Technical Service Bulletin

MODEL(S) AFFECTED: **T391** - North America Market
Models manufactured before production date: May 2024

SUBJECT: A common issue has been identified where machine may not pick up water as expected. After evaluation, if the left and right squeegee blade retainer straps are inadvertently installed upside down, the straps will prevent the blades to properly deflect (bend at a 45° angle as shown below) to obtain optimum pick up performance.

Squeegee blade retainer straps properly installed

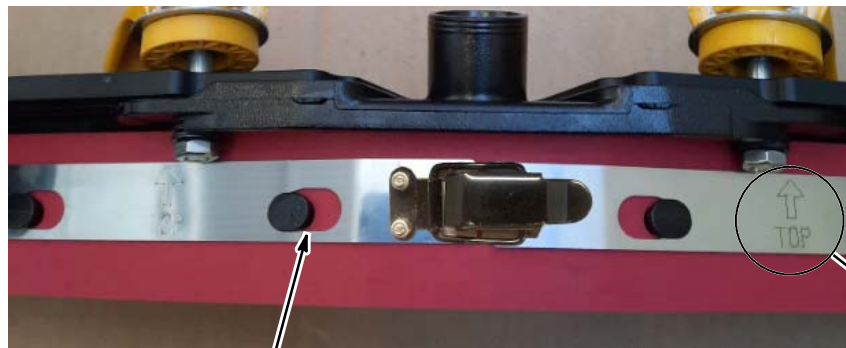
Note: The slots in the strap are vertically off-centered. If the straps are installed upside down, the strap moves closer to the floor as shown below, restricting proper blade deflection.

PURPOSE: To resolve issue, simply install the straps according to the installation instructions described in the operator manual, also as shown in photo below.

NOTES: Standard warranty terms applies.
For models manufactured after April 2024, the retainer straps now include an indicator ("TOP" w/ arrow pointing upward) for installation guidance.
